**NORTH CAROLINA
DIVISION OF AIR QUALITY
Application Review**

<p style="text-align: center;">Facility Data</p> <p>Applicant (Facility's Name): Shurtape Technologies - Hickory/Highland Plant</p> <p>Facility Address: Shurtape Technologies - Hickory/Highland Plant 1620 Highland Avenue, NE Hickory, NC 28601</p> <p>SIC: 2672 / Paper Coated And Laminated, Nec NAICS: 322222 / Coated and Laminated Paper Manufacturing</p> <p>Facility Classification: Before: Title V After: Title V Fee Classification: Before: Title V After: Title V</p>	<p style="text-align: center;">Permit Applicability (this application only)</p> <p>SIP: 02Q .0516 NSPS: N/A NESHAP: N/A PSD: GHGs PAL Renewal PSD Avoidance: N/A NC Toxics: N/A 112(r): N/A Other: N/A</p>
--	--

<p>Review Engineer: Rahul Thaker</p> <p>Review Engineer's Signature: _____ Date: October 1, 2021</p>	<p style="text-align: center;">Comments / Recommendations:</p> <p>Issue 02218/T38 Permit Issue Date: xx Permit Expiration Date: xx</p>
---	--

Shurtape Technologies – Hickory/Highland Plant (“Shurtape”), Hickory, Catawba County, North Carolina, submitted a permit application on July 14, 2021 to renew the current PAL (Actuals Plantwide Applicability Limita

Figure 5-1:
Revised GHGs Baseline Using Top 15 Products Produced in Coating Line 5

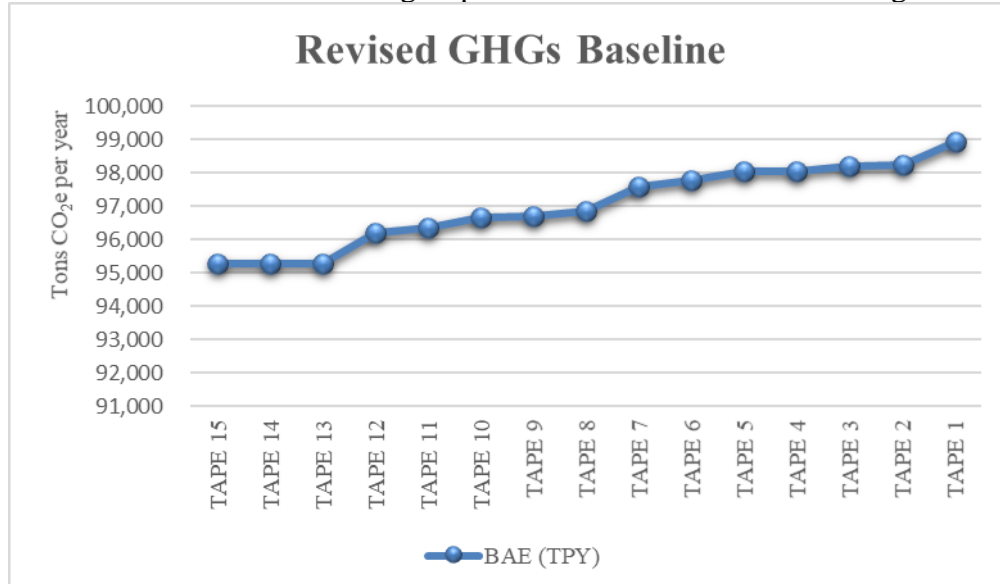
Table 5-6 below shows the calculated additional GHGs emissions that would result due to manufacturing of any of the top 15 products (i.e., Tape 1 through Tape 15 in Table 5-5 above) on Coating Line 5 for 8760 hours and exhausting to the RTO. The additional GHGs emissions generated from manufacturing these top 15 products for 8760 hours per year range from 4,339 TPY to 8,663 TPY as CO₂e, above the levels in the baseline calculations. Thus, the revised baseline is estimated to be between 95,262 and 98,948 TPY as CO₂e, which is also charted in Figure 5-1 below. Thus, in accordance with the said EPA guidance, a more representative BAEs, reflective of realistic facility emissions from actual coatings utilized during the contemporaneous period, is above 80% of the current GHG PAL Level. More specifically, it ranges between 83.4% to 86.6% of the current PAL.

Considering the totality of circumstance and the reasoned basis above, DAQ agrees that the facility's actual emissions for GHGs during the selected baseline period (October 2017 through September 2019) could be as high as 84-86% of the current PAL, when factored into source-specific factors as discussed above. Thus, they do meet the 02D .0530(i) criteria for renewing the GHGs PAL at the current PAL (114,271 TPY CO₂e). However, as discussed earlier and shown in Table 5-4 above, the facility's PTE has decreased below the current PAL to a level of 106,205

TPY CO₂e. Thus, in accordance with 15A NCAC 02D .0530(i) and §51.166(w)(10)(iv)(c), the DAQ adjusts the current GHGs PAL and proposes to renew it at a level of 106,205 TPY CO₂e. The DAQ concludes that this renewed level is reasonably representative of facility's baseline actual emissions.
